METROPOLITAN DEVELOPMENT COMMISSION
HEARING EXAMINER

Case Number: 2025-CPL-861 / 2025-CVR-861
Property Address: 9425 Hague Road (approximate address)
Location: Lawrence Township, Council District #4
Petitioner: Waffle House, Inc., by Eric Givens
Zoning: C-4 (FF)
Request: Approval of a Subdivision Plat, to be known as Waffle House Addition, dividing 1.65 acres into two lots, with a waiver of the sidewalk requirement.
Variance of Development Standards of the Consolidated Zoning and Subdivision Ordinance to provide for the development of a restaurant, without the installation of a public sidewalk along Hague Road or Castlegate Drive (public sidewalks are required along the entire frontage of abutting public rights-of-way), to provide for 9-foot by 18-foot parking stalls (minimum parking stall size of 9-foot by 20-foot, or 10-foot by 18-foot, or 180 square-foot required), and to provide for 36 parking spaces (maximum 18 parking spaces permitted).
Waiver Requested: Yes

STAFF RECOMMENDATION

SITE PLAN

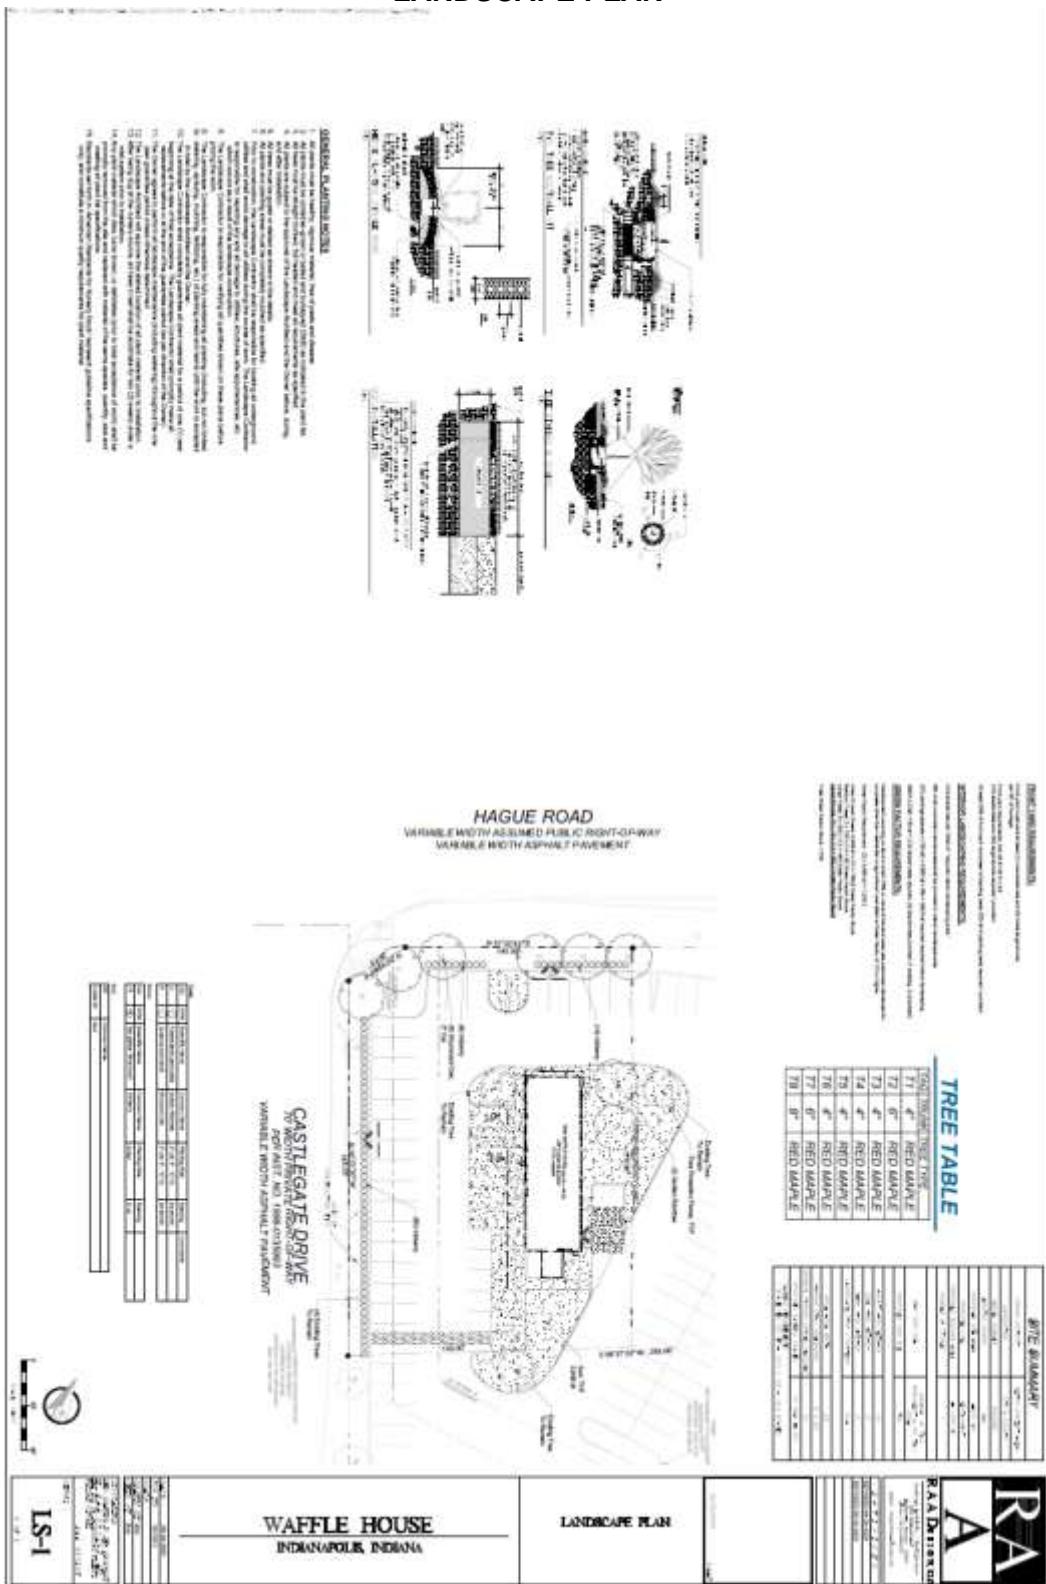
Staff does not support the variance for the reduction in parking stalls. The site plan calls out eight spaces along Hague Road that would be reduced in size, but a simple change in the parking space widths to 10 feet would ensure that the minimum 180 square feet is met. Additionally, these parking spaces could simply be eliminated, and additional landscaping could be proposed in their place considering the proposal would exceed the maximum parking spaces.

Although the number of parkign spaces may already exist on site, nothing prevents the developer from eliminating the excess parking spaces to accommodate the required parking dimensions of the

Ordinance. If the minimum parking stall sizes were met, then staff could consider supporting the remaining existing parking spaces on site.

Sidewalks are required as a part of this plat. Sidewalks do not exist along Hague Road or Castlegate Drive. The petitioner is seeking a waiver of the sidewalk requirement along both streets. Staff understands that sidewalks are an important and necessary infrastructural element of public rights-of-way that increases connectivity, access, and safety for any members of the public not using a motor vehicle. With both streets currently not containing any sidewalks, Staff finds the requirement to implement sidewalks as a part of this platting process to be an important first step in building out the pedestrian network and improving access along Hague Road and Castlegate Drive. Further, Staff did not find there to be any physical difficulties/obstructions that would complicate/prohibit the placement of sidewalks at this location.

Lot Two would not be directly adjacent to the public right-of-way of Hague Road due to the existence of a small parcel that separates it from the street. However, the Ordinance allows for the Administrator to approve a different location of the sidewalk which in this case would be recommended to be along the north property boundary. While this won't directly connect this section of the sidewalk to the existing section of sidewalk at the eastern corner of Hague Road and Castlegate Drive, it will ensure a future connection could be possible in the future.

Therefore, Staff is not supportive of the waiver request, and recommends that sidewalks be placed along both street frontages.
